Addendum No.1

Project: Audie Murphy Hospital - Replace HVAC Units - Phase IV

Issuance Date: June 13, 2014

Item No. 2 Sheet M-104 - BASEMENT PIPE SPACE PIPING PLAN

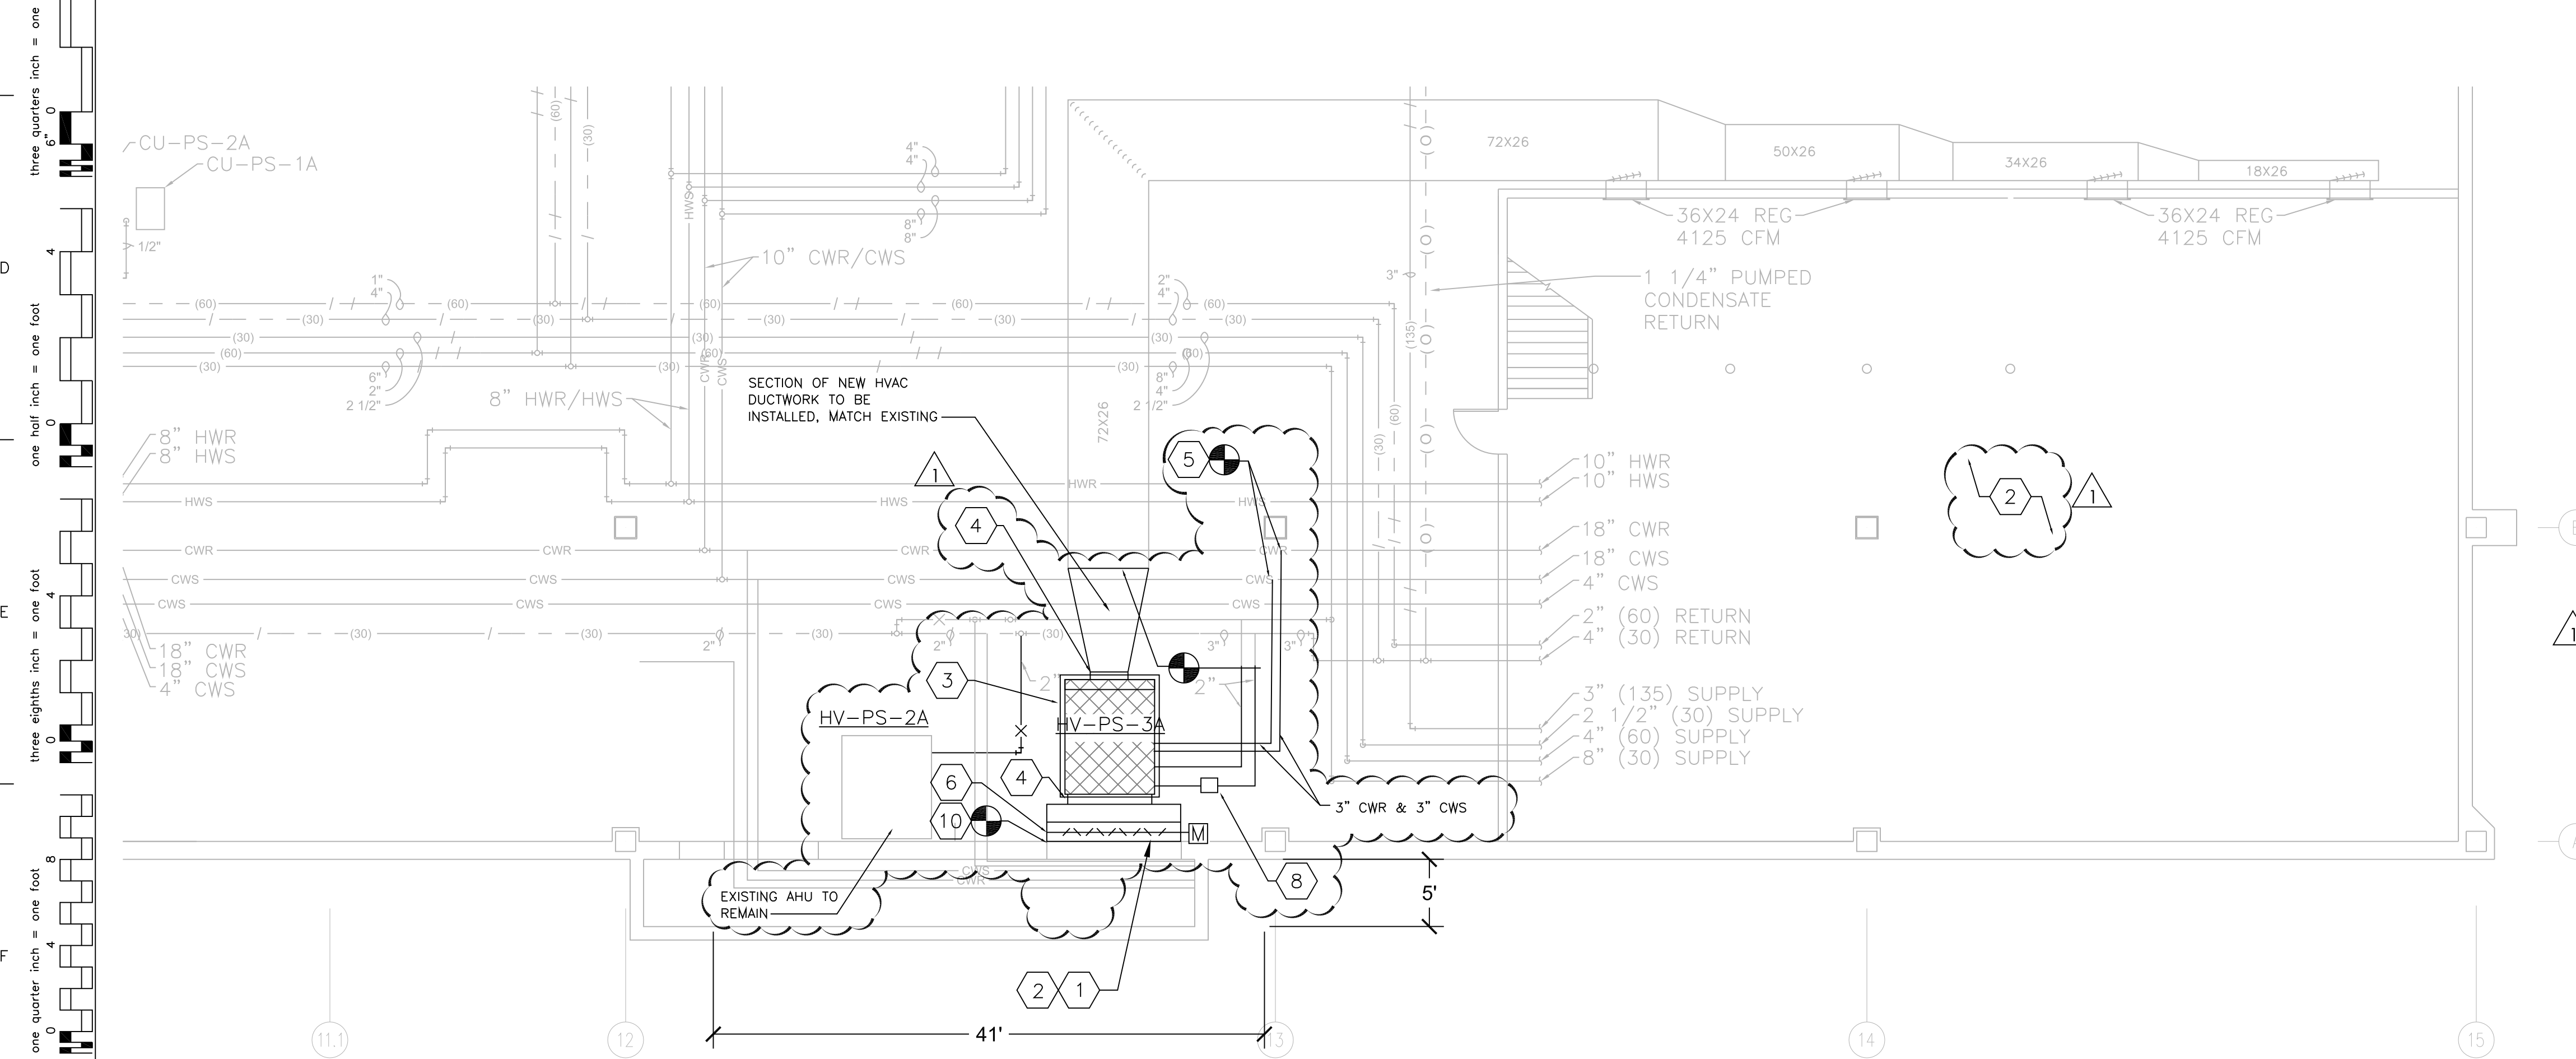
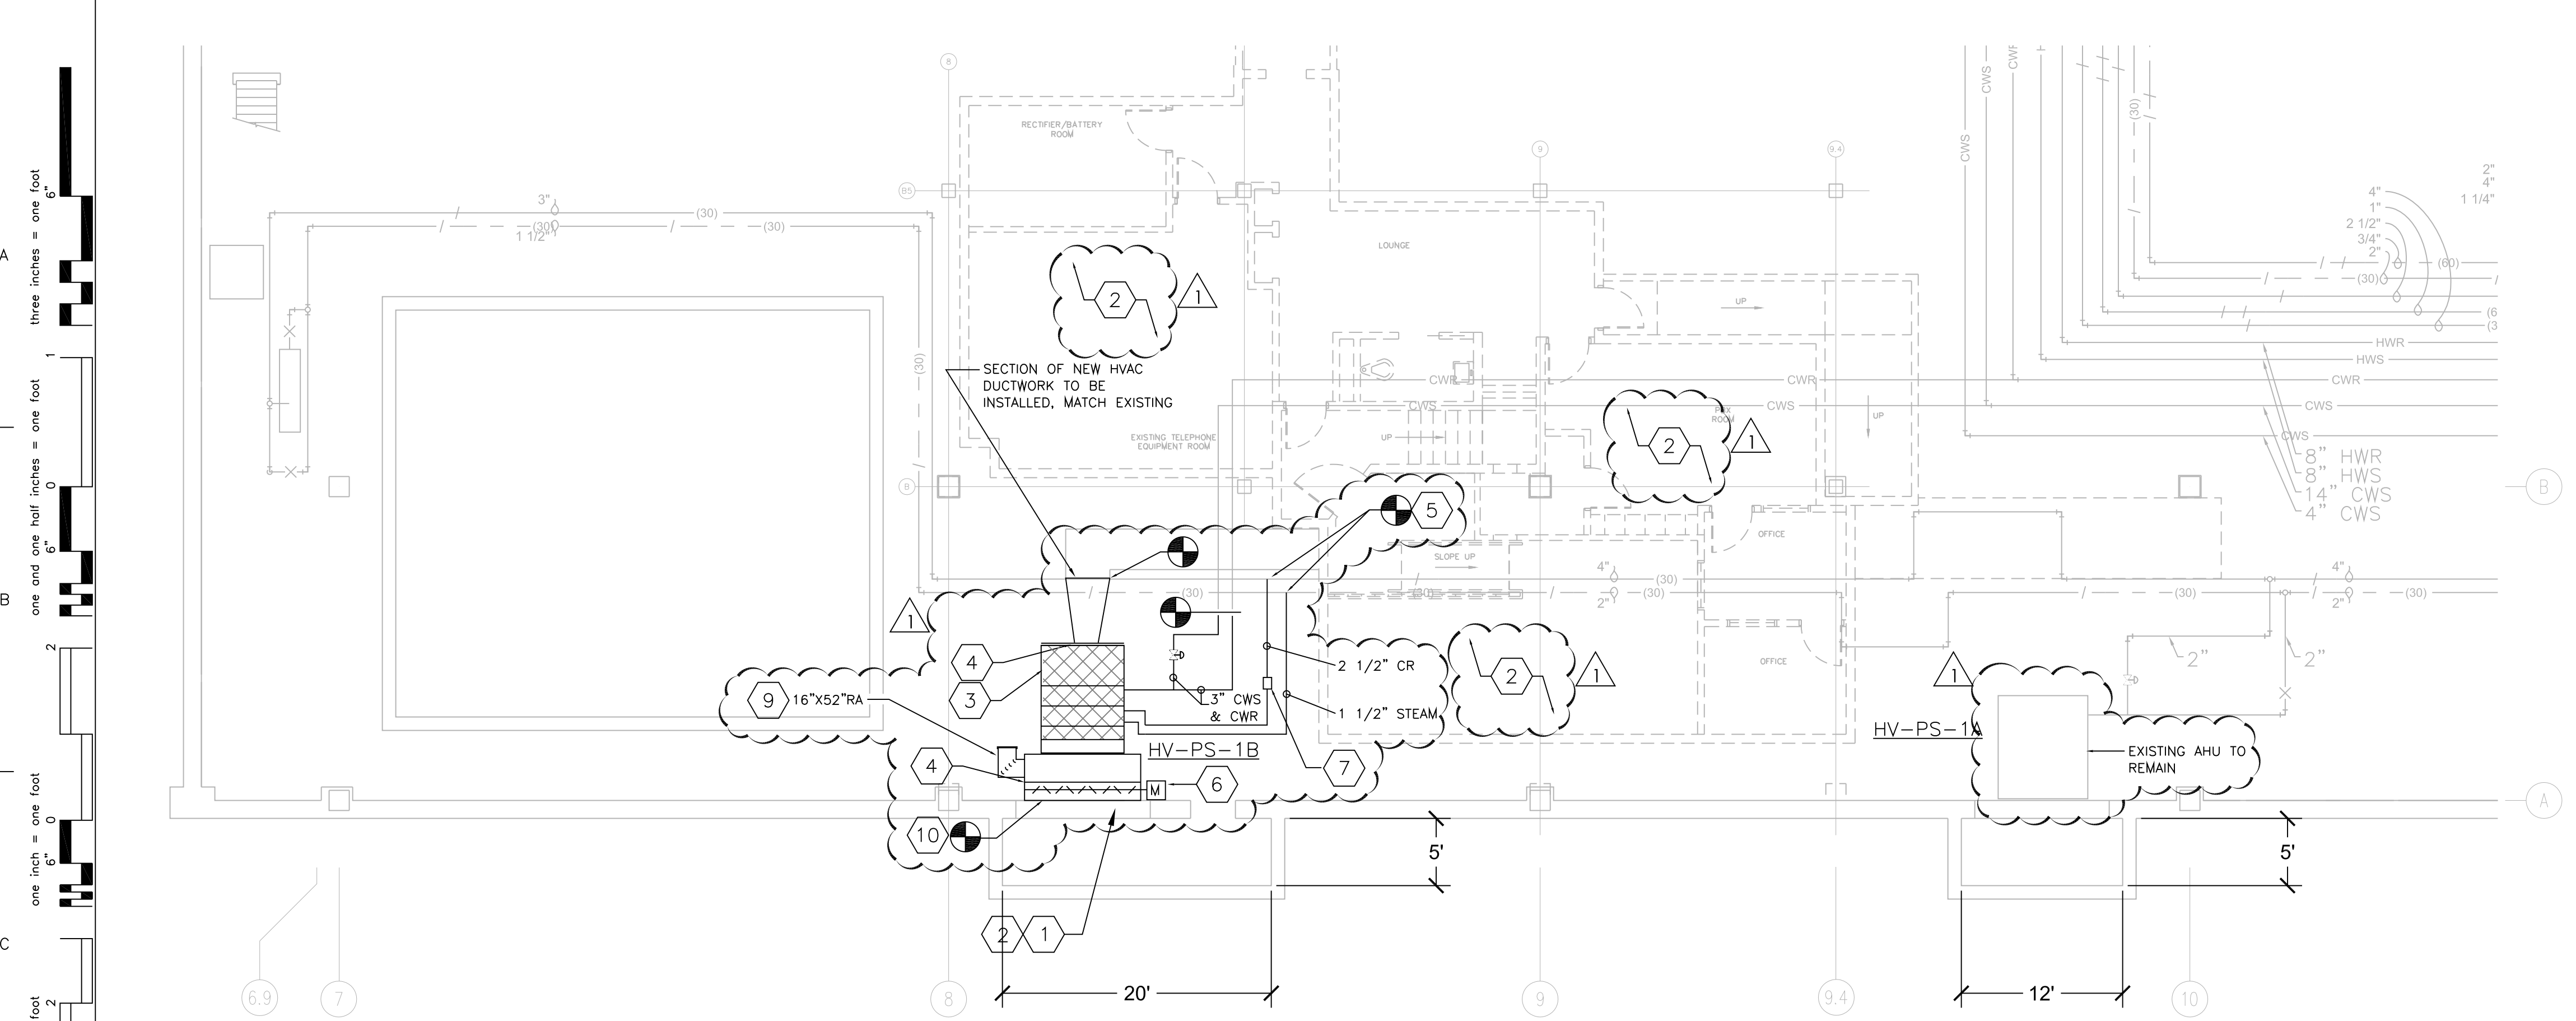
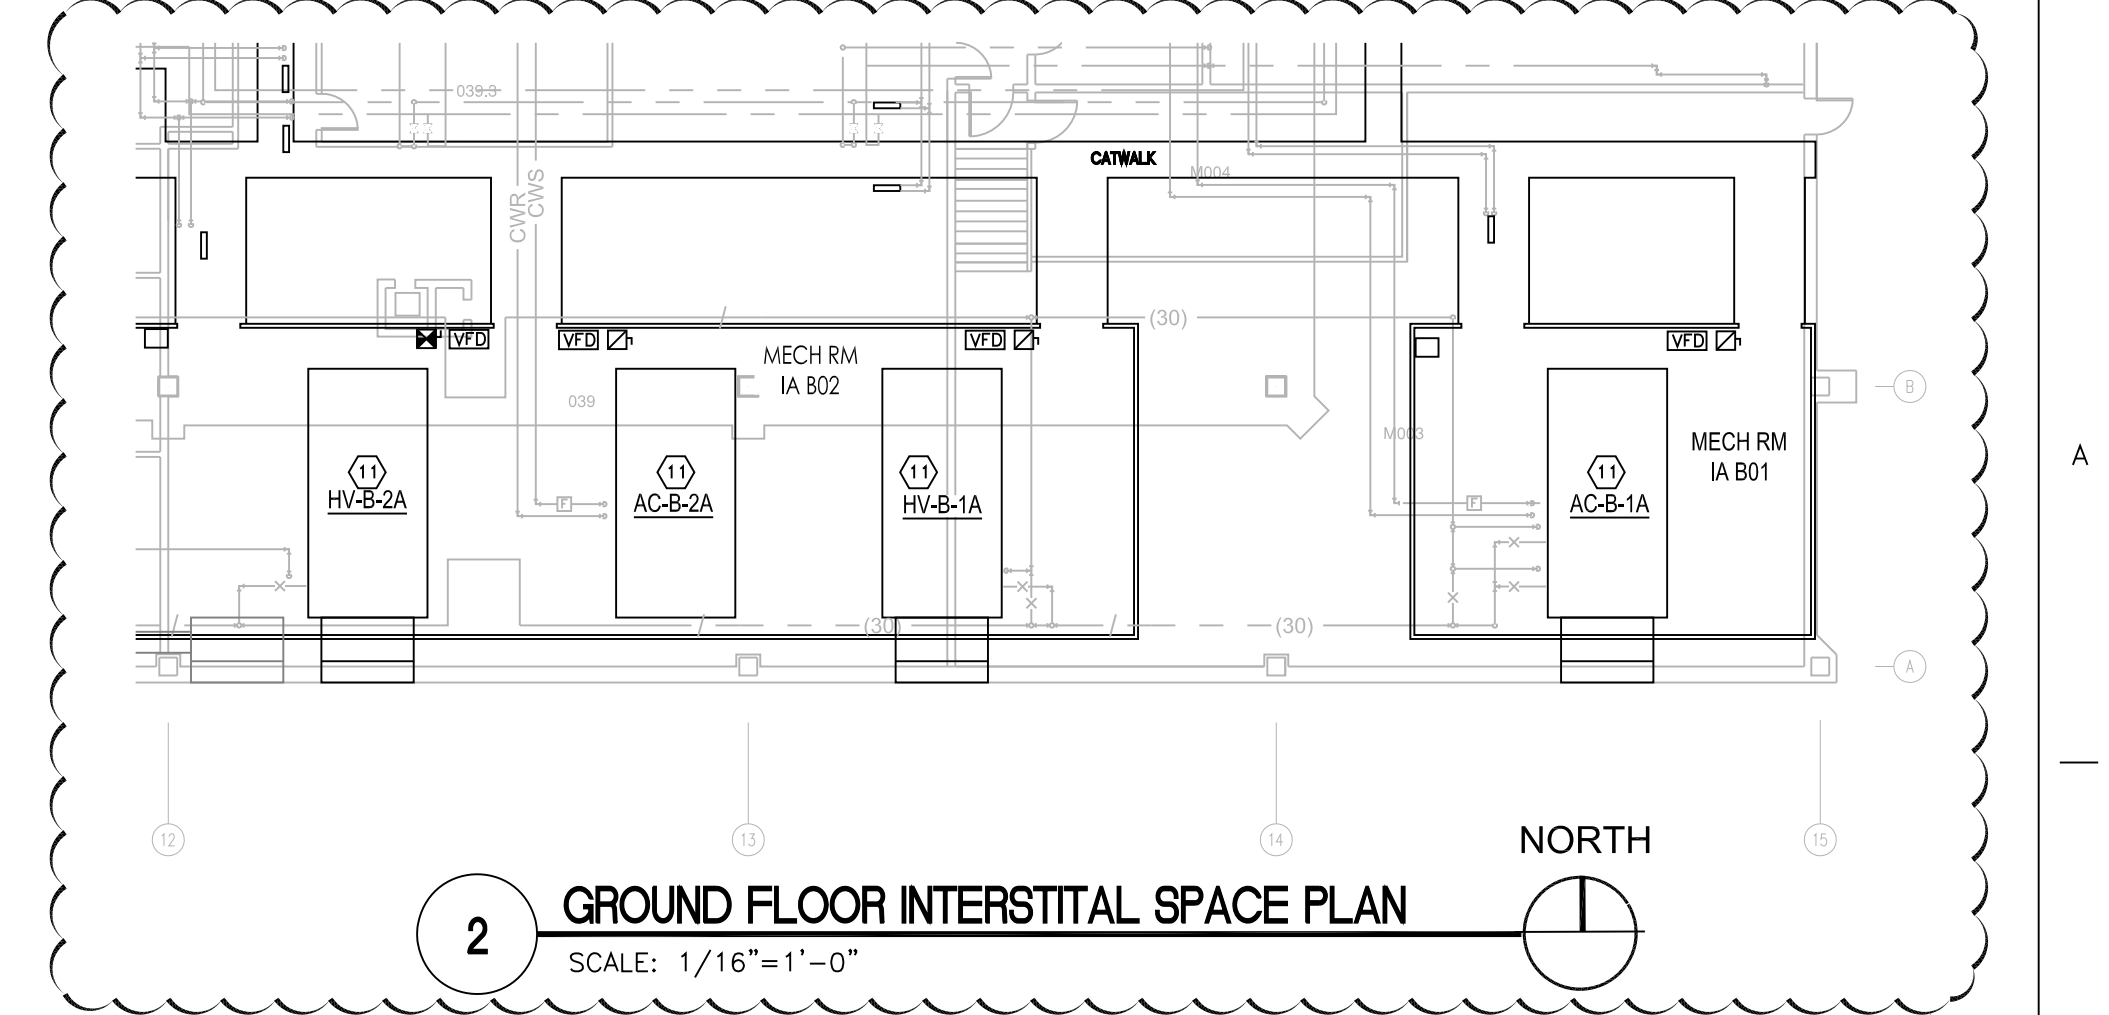
1. The Contractor shall furnish and install the Air Handling Units, piping and appurtenances as shown on the attached drawing.

Item No. 6 Sheet E-104 - BASEMENT PIPE SPACE ELECTRICAL PLAN

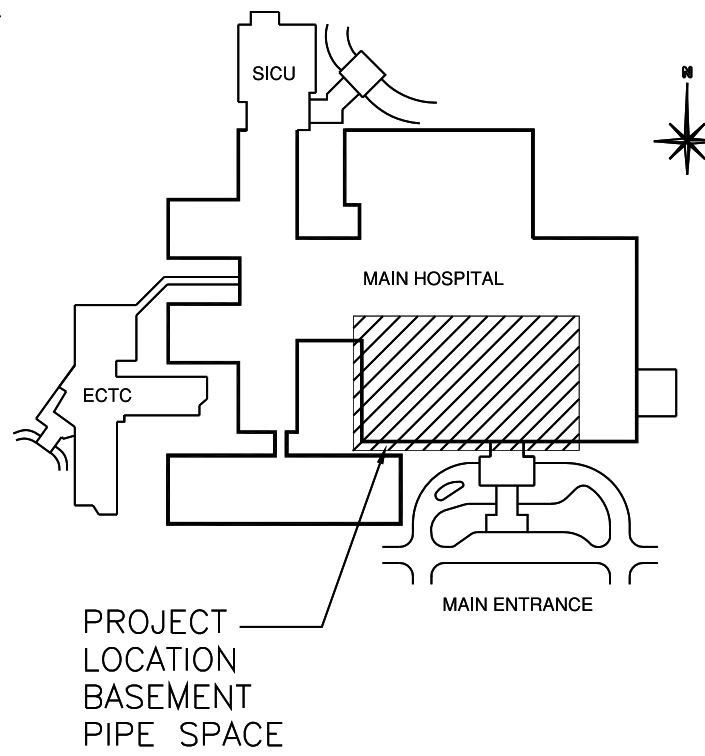
1. The Contractor shall furnish and install electrical gear, circuits, etc. as shown on the attached drawing.
